Natural Environment Referral Response - Biodiversity

Application Number:	DA2023/0306
Proposed Development:	Alterations and additions to a dwelling house including a swimming pool
Date:	12/05/2023
Responsible Officer	Brittany Harrison
Land to be developed (Address):	Lot 15 DP 1189590, 20 Spring Cove Avenue MANLY NSW 2095

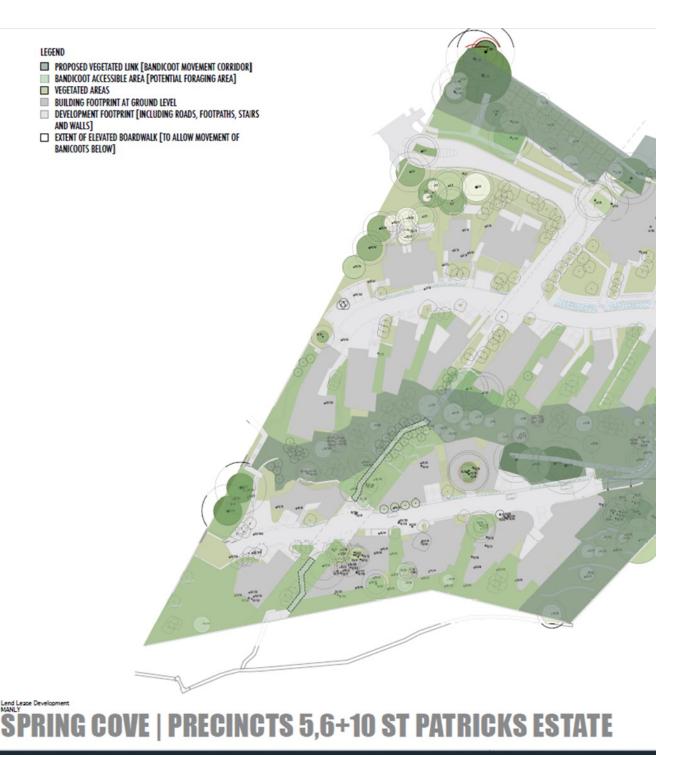
The proposal would take place in the "vegetated link" (bandicoot movement corridor), which is required to be maintained as bandicoot habitat under the Spring Cove Bandicoot Habitat Plan of the original estate consent. As the development would result in the removal of this vegetated link, compensatory planting is required to be undertaken elsewhere on the property to ensure no net loss of bandicoot habitat. Proposed measures to ensure no net loss of bandicoot habitat must be confirmed before compliance with relevant biodiversity controls can be assessed, and may be demonstrated by either an amended landscape plan (showing proposed areas of improved bandicoot habitat elsewhere on the site), or an ecology report (prepared by a suitably qualified ecologist) outlining proposed bandicoot habitat replacement measures.

The proposal is therefore unsupported.
